# Staff Summary Report

**SUBJECT:** A public meeting for a Development Plan Review for MCDONALD'S RESTAURANT, located at 1325 W. Broadway Road.

**DOCUMENT NAME:** DRCr\_McDonalds\_110910 **PLANNED DEVELOPMENT (0406)**

**DPR010186** – Development Plan Review including site plan, building elevations, and landscape plan.

A1  
FLOOR PLAN

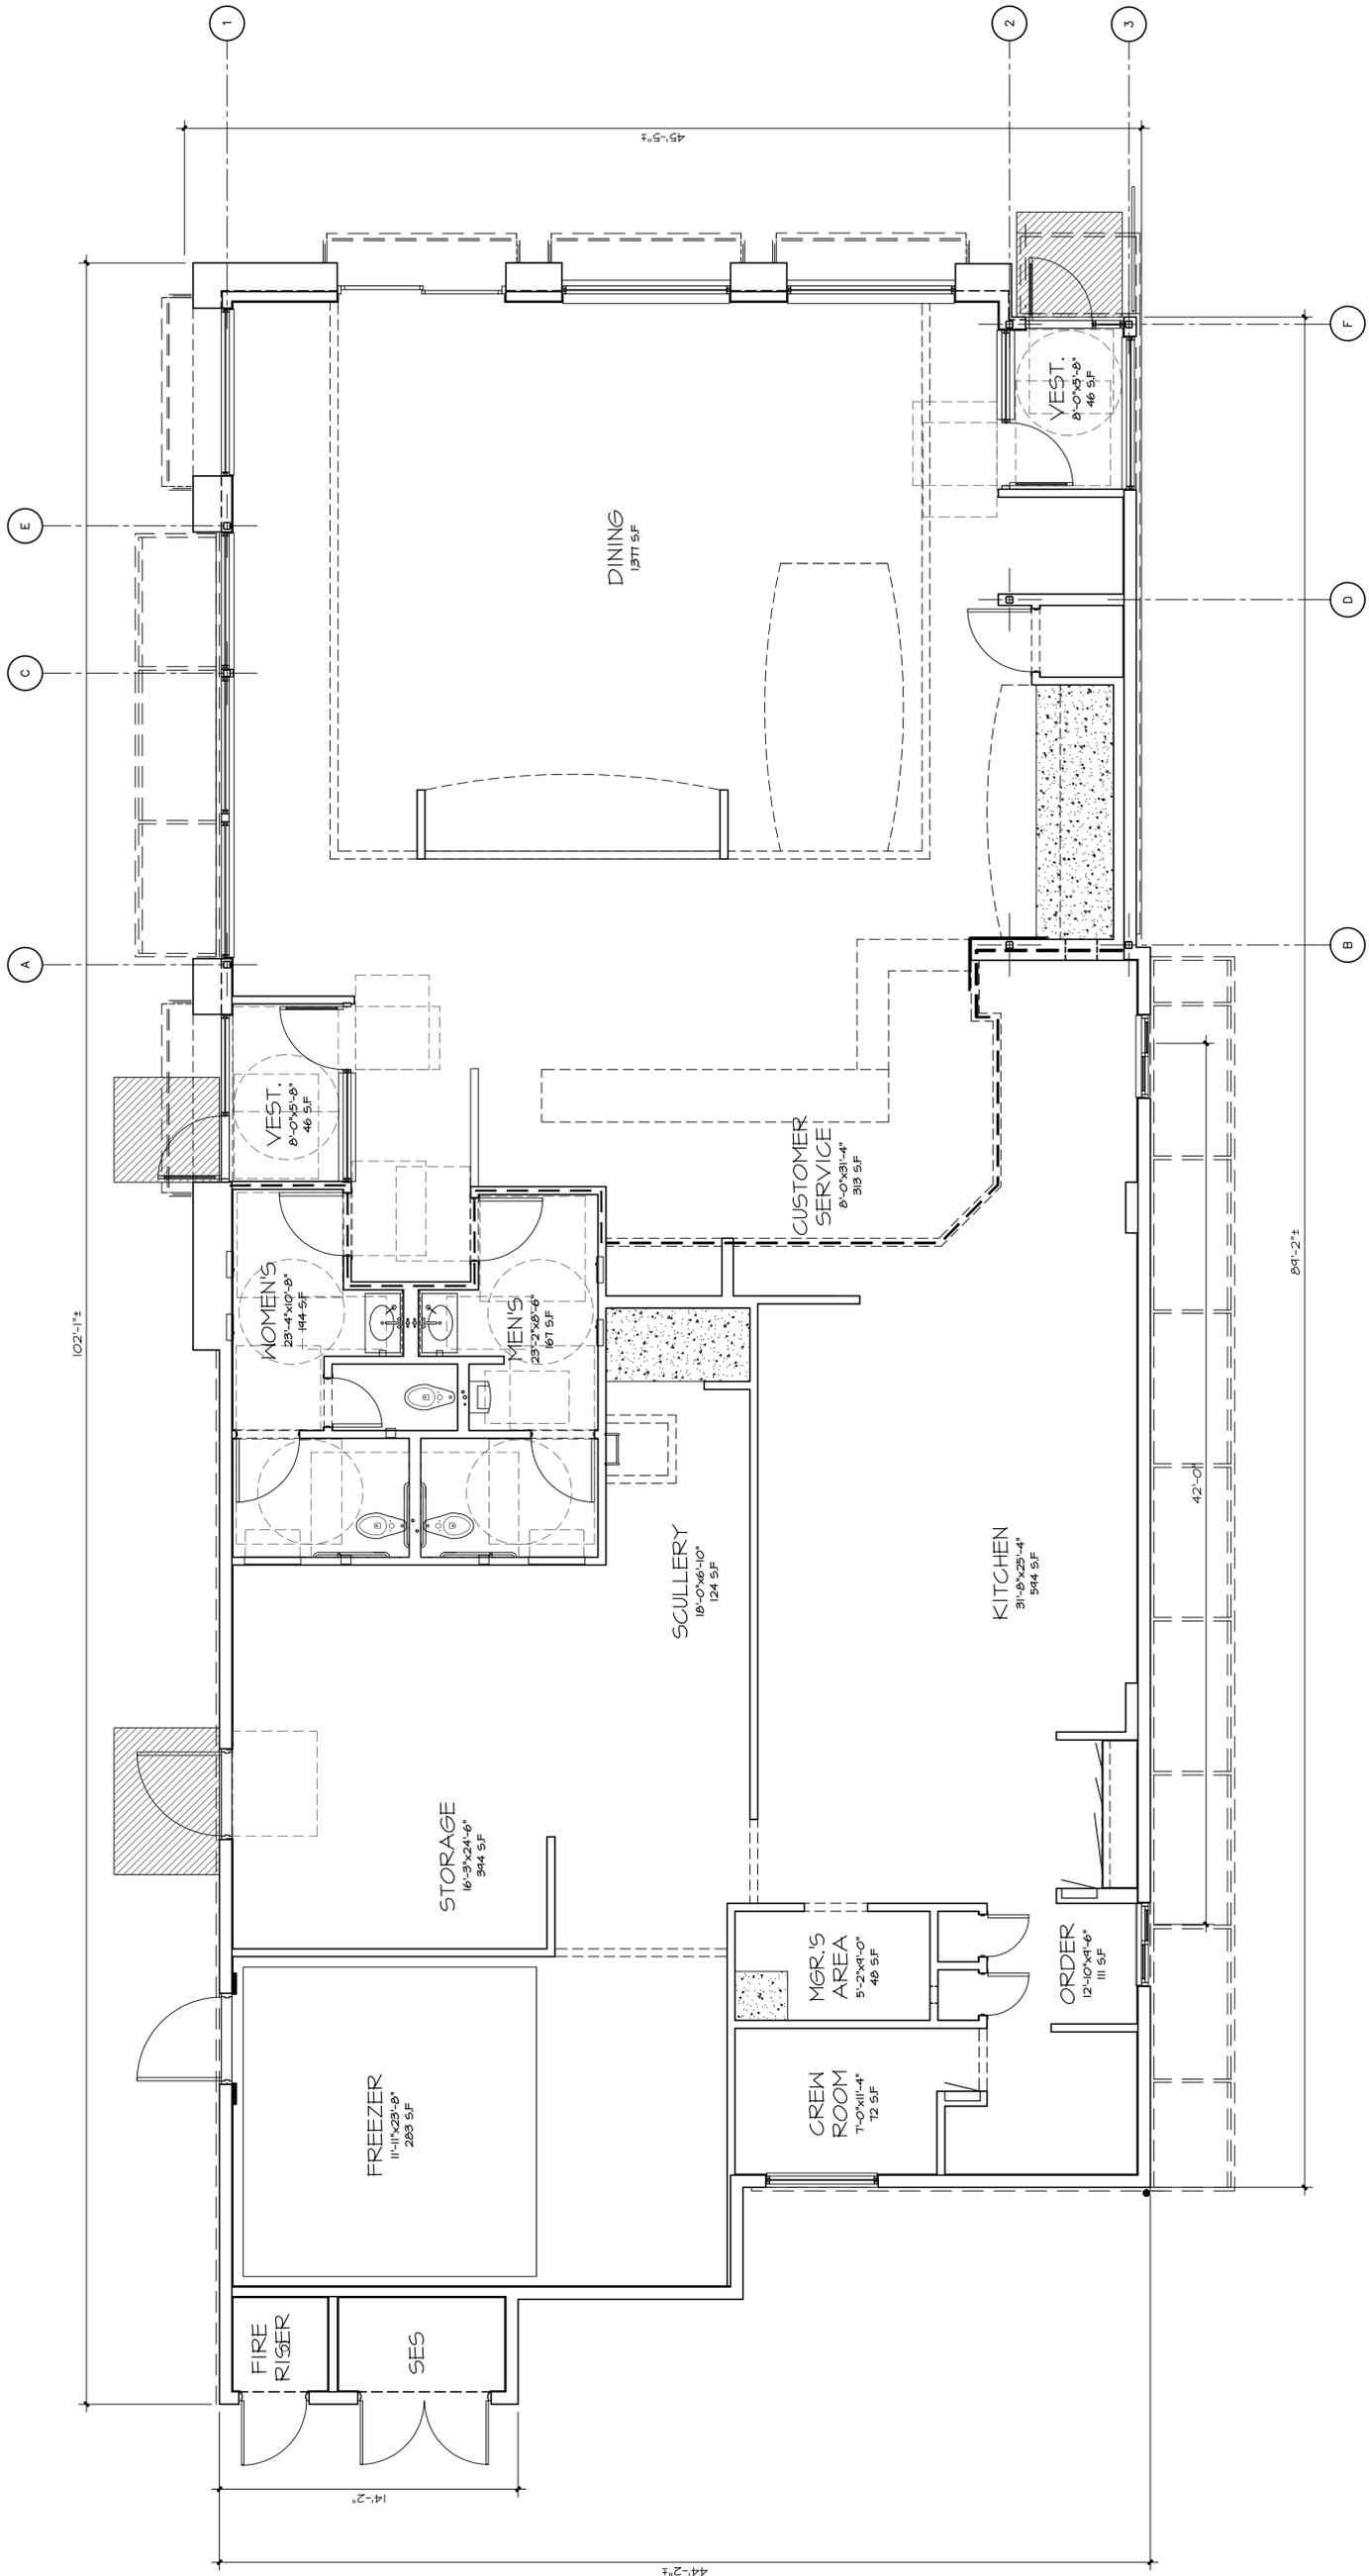
9. Public Restroom Security:
  - a. Lights in restrooms:
    - 1) Provide 50% night lights
    - 2) Activate by automatic sensors, key or remote control mechanism
  - b. Single user restroom door hardware:
    - 3) Provide a key bypass on the exterior side

**A2**  
EXTERIOR  
ELEVATIONS

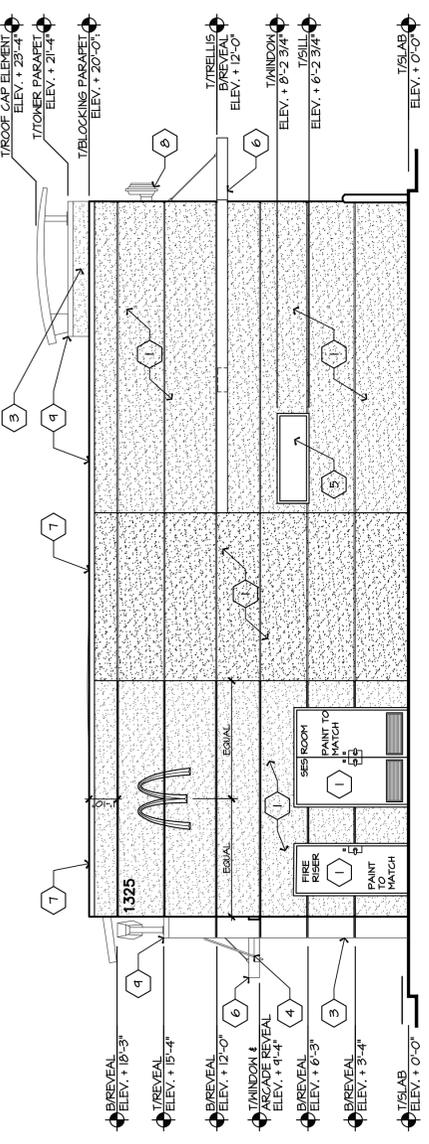
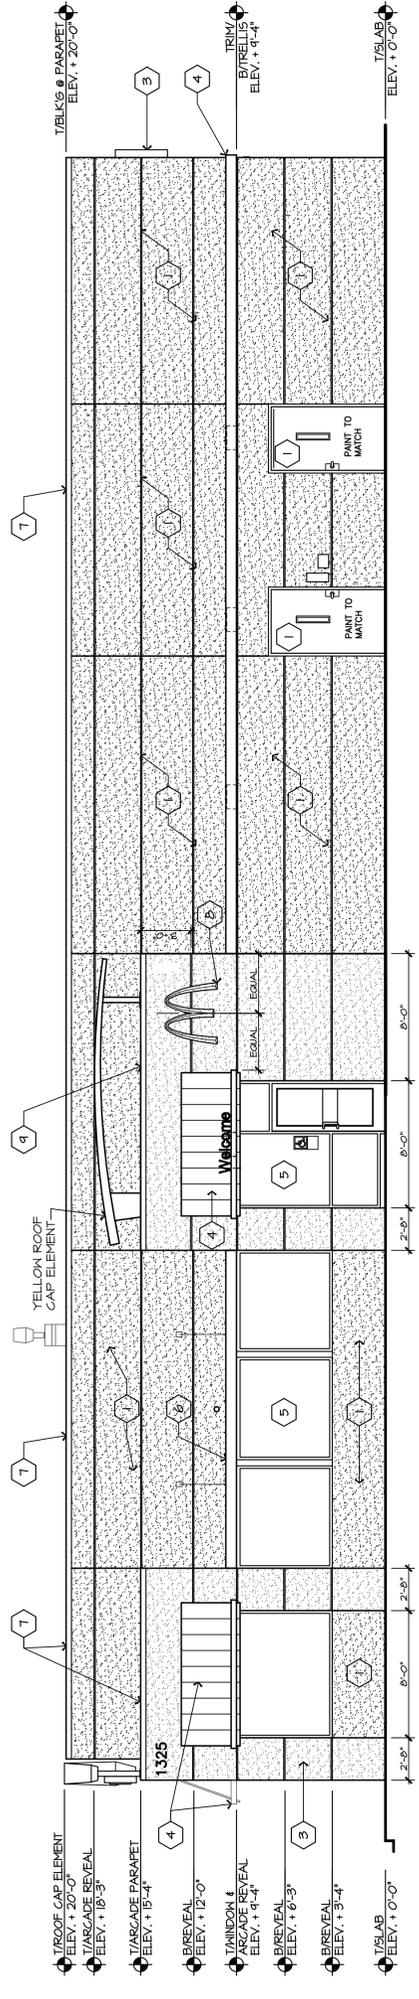
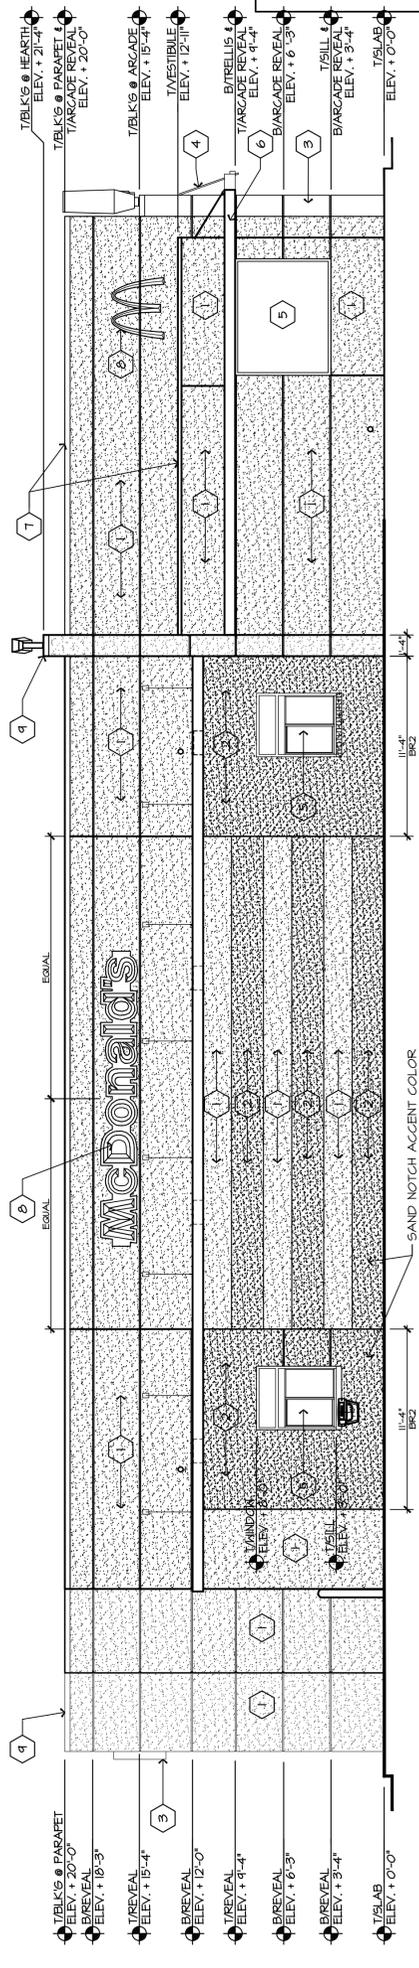
The single-story 21-foot tall building has a strong horizontal form, broken by small canopies over the front patio on the north and the drive-through lane on the west side of the site. Staff had recommended a larger patio canopy, similar to the drive-through canopy, however, the corporate design intent is to provide shade with umbrellas at the tables. The contemporary design incorporates neutral colors accented by corporate primary yellow. Windows and a sliding glass door facing Broadway Road provide visual surveillance of the patio from the dining and sales area inside. The north (front) façade has the sliding glass door and large floor to ceiling windows; the east elevation has a standard swing door as the primary entrance to the restaurant and glazing in the dining room portion of the elevation; the south (rear) provides one clerestory window into the crew break room to minimize sun exposure and provide security to the back of house of the business; the west side has one window into the dining room, and two sliding windows for drive-through service, minimizing sun exposure into the space. The primary building is stucco painted "Huntington Beige" a dark beige color, this is accented with "Linen" a warm cream tone at the entrance and dining areas. The drive-through is accented by "Mink" a dark brown tone that gives the impression of a shadow, or recessed area, creating depth and emphasis of the drive-through area. The canopies are gold and yellow painted metal, with a clear anodized aluminum frame.

10. The materials and colors are approved as presented:

Roof: flat  
Main building – Stucco – painted Huntington Beige #HC-21 by Benjamin Moore  
Arcade Front, Side and Hearth – Stucco – painted Linen Sand #2151-60 by Benjamin Moore  
Canopy, coping, awning frame, arcade storefront and entry door – clear anodized aluminum frame  
Awnings – aluminum and vinyl – Yellow Formula N3476HW by Dupont Imron 5000 and Gold #3632-25 by 3M  
Provide main colors and materials with a light reflectance value of 75 percent or less. Specific colors and materials exhibited on the materials sample board are approved by planning staff. Submit any additions or modifications for review during building plan check process.
11. Provide secure roof access from the interior of the building. Do not expose roof access to public view.

12. Conceal roof drainage system within the interior of the building.
13. Incorporate lighting, address signs, and incidental equipment attachments (alarm klaxons, security cameras, etc.) where exposed into the design of the building elevations. Exposed conduit, piping, or related materials is not permitted.
14. Avoid upper/lower divided glazing panels in exterior windows at grade level, particularly where lower (reachable) glass panes of a divided pane glass curtain-wall system can be reached and broken for unauthorized entry. Do not propose landscaping or screen walls that conceal area around lower windows. If this mullion pattern is desired for aesthetic concerns, laminated glazing may be considered at these locations.

**PROJECT DATA**  
 1325 W. BROADWAY ROAD - TEMPE, ARIZONA  
 L/C: 02-0036  
 REGISTERED IN THE U.S. PATENT AND TRADEMARK OFFICE  
 © 1988 MCDONALD'S CORPORATION  
 4587  
 5' FRONT / 5' REAR+  
 SES FIRE RISER RM  
**L1**  
 CONCEPTUAL  
 LANDSCAPE PLAN

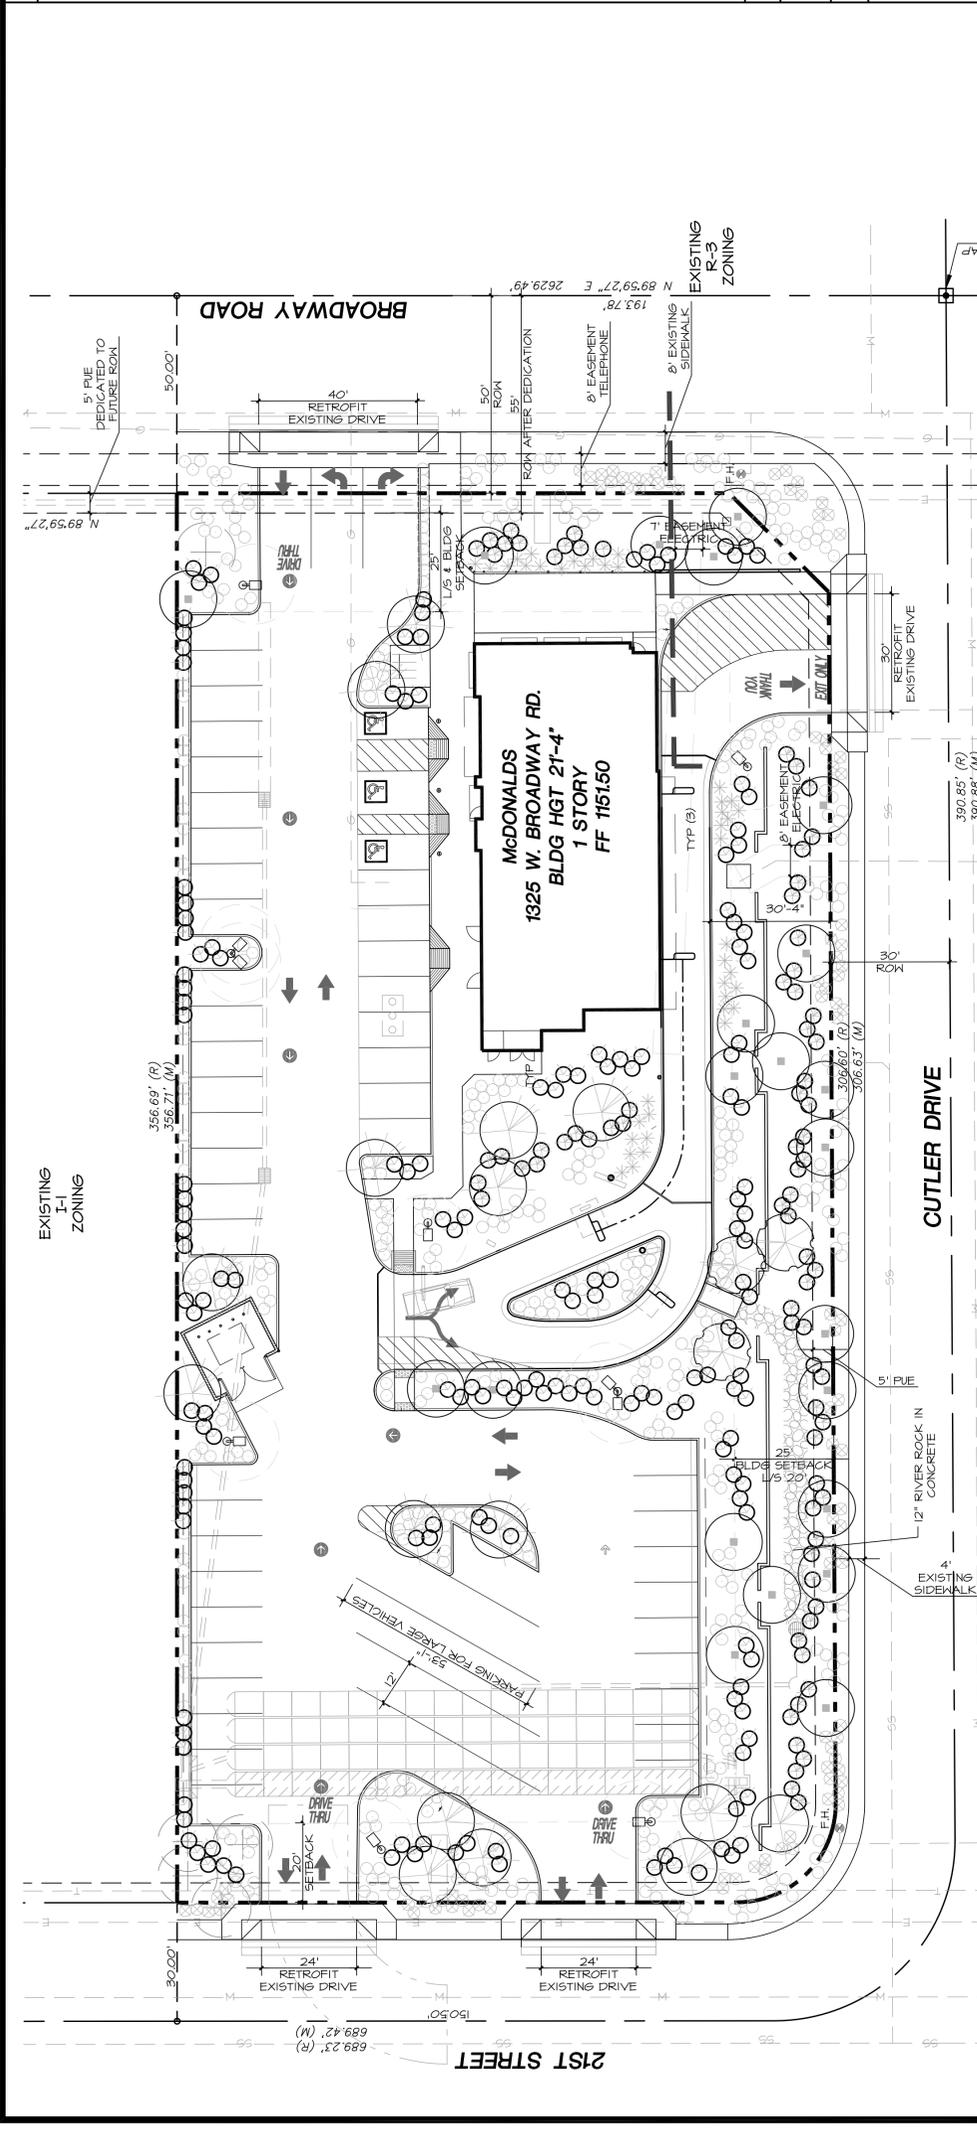
The landscape is being updated to remove high water using plants with new low-water using species. All but five of the existing mature trees will be removed. These trees are now designated on our prohibited plant list, eucalyptus and pollen producing olive trees. New species of trees would include Sonoran Palo Verde, Shoestring Acacia, Virginiana Oak, and existing palm and pine trees. Shrubs and ground cover include Sage, Ruellia, Lantana, Bush Morning Glory and Gazania planted in Madison Gold decomposed granite. Trees are being located to provide shade on the sidewalk, on portions of the drive-through, and as required within the parking lot. A screen wall will replace the existing turf berm, and a swail of rocks will lead to the underground retention grate. Lighting will be coordinated to minimize conflicts with trees. The plants along the Broadway frontage will provide a physical buffer for the patio, but allow visual surveillance of the public sidewalk. The patio will be approximately 14 feet from the new right of way dedication, and approximately 25 feet from the back of the sidewalk. The proposed plan will significantly reduce water consumption by removal of the turf.

16. Relocate proposed light locations to comply with required trees in parking lot landscape islands.
17. The plant palate is approved as proposed and specified on the landscape plan. Any additions or modifications may be submitted for review during building plan check process.

18. Irrigation notes:
  - a. Provide dedicated landscape water meter.
  - b. Provide pipe distribution system of buried rigid (polyvinylchloride), not flexible (polyethylene). Use of schedule 40 PVC mainline and class 315 PVC ½" feeder line is acceptable. Class 200 PVC feeder line may be used for sizes greater than ½" (if any). Provide details of water distribution system.

19. Include requirement to de-compact soil in planting areas on site and in public right of way and remove construction debris from planting areas prior to landscape installation.

20. Top dress planting areas with a rock or decomposed granite application. Provide rock or decomposed granite of 2" uniform thickness or less. Provide pre-emergence weed control application and do not underlay rock or decomposed granite application with plastic.
